PCN #: 2540

PCN Title: Qualified Additional Fab Site, Assembly/Test (A/T) Sites, Bill of Material (BOM) and updated Device Data Sheets

**PRODUCT CHANGE NOTICE****PCN-2540 REV 1**

PI7C9X118SL

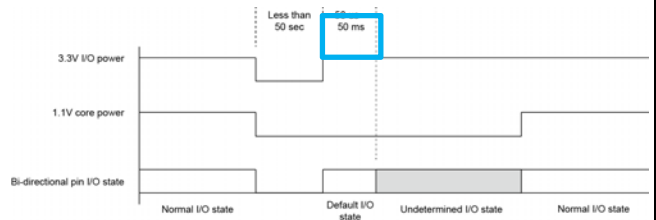
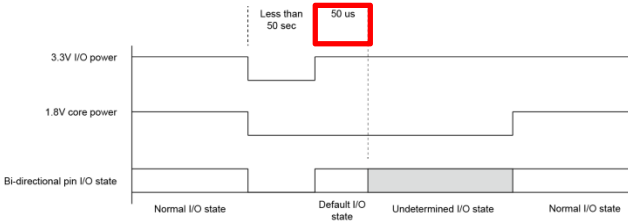
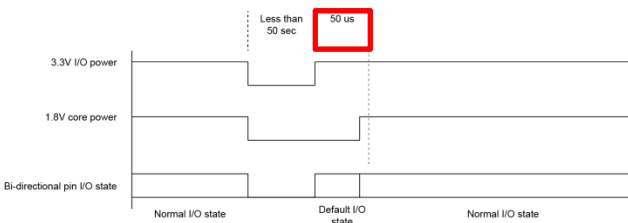
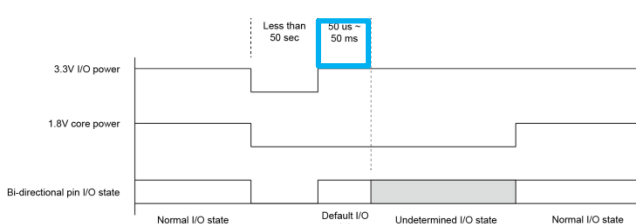
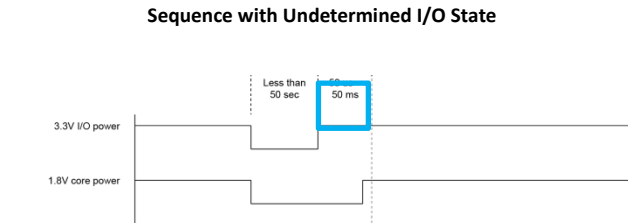
Current Data Sheet	New Data Sheet
<h3>14 POWER SEQUENCING</h3> <p>The PI7C9X118SL requires two voltages: 3.3V I/O voltage and 1.1V core voltage. The 1.1V VDDCAUX is consider the same as core voltage, and can be combined as one. When designing the power supplies for PI7C9X118SL, the user can either apply ALL voltages at the same time, or turn on the higher voltage (3.3V) first, followed by the lower voltages (1.1V) within suggested limits. If all power rails are not applied at the same time, the PI7C9X118SL will not be damaged as long as 3.3V is applied either before or at the same time as 1.1V.</p> <p>During power cycle, if there is a delay in applying 1.1V core voltage after the 3.3V is applied, the internal logic might be placed in an unknown state if the power off period is not long enough to cause PI7C9X118SL totally discharged. This condition in turn may produce undetermined I/O states on some pins. If the core logic is totally discharged before applying 3.3V, then all bi-directional I/O pins will stay at their default states.</p> <p>The typical time for PI7C9X118SL to discharge completely is less than 3 seconds, but in extreme cases this period can be as long as 50 seconds. Certain precautions should be made if the delay between 3.3V and 1.1V is larger than 50us. Figure 14-1 below shows the I/O timing sequence</p>	<h3>14 POWER SEQUENCING</h3> <p>The PI7C9X118SL requires two voltages: 3.3V I/O voltage and 1.1V core voltage. The 1.1V VDDCAUX is consider the same as core voltage, and can be combined as one. When designing the power supplies for PI7C9X118SL, the user can either apply ALL voltages at the same time, or turn on the higher voltage (3.3V) first, followed by the lower voltages (1.1V) within suggested limits. If all power rails are not applied at the same time, the PI7C9X118SL will not be damaged as long as 3.3V is applied either before or at the same time as 1.1V.</p> <p>During power cycle, if there is a delay in applying 1.1V core voltage after the 3.3V is applied, the internal logic might be placed in an unknown state if the power off period is not long enough to cause PI7C9X118SL totally discharged. This condition in turn may produce undetermined I/O states on some pins. If the core logic is totally discharged before applying 3.3V, then all bi-directional I/O pins will stay at their default states.</p> <p>The typical time for PI7C9X118SL to discharge completely is less than 3 seconds, but in extreme cases this period can be as long as 50 seconds. Certain precautions should be made if the delay between 3.3V and 1.1V is larger than 50us. Figure 14-1 below shows the I/O timing sequence</p>

When 1.1V core power is applied after 3.3V IO power is applied, there might be glitch at reset pins (PERST_L and RESET_L), and an external RC filter can be used to filter out the glitch if necessary.

If the gap between 3.3V IO power and 1.1V core power is too big, there might be glitch at pin RESET_L. The maximum gap is recommended to be 50us~50ms, customer needs to measure the waveform of RESET_L to make sure there is no glitch during the gap.
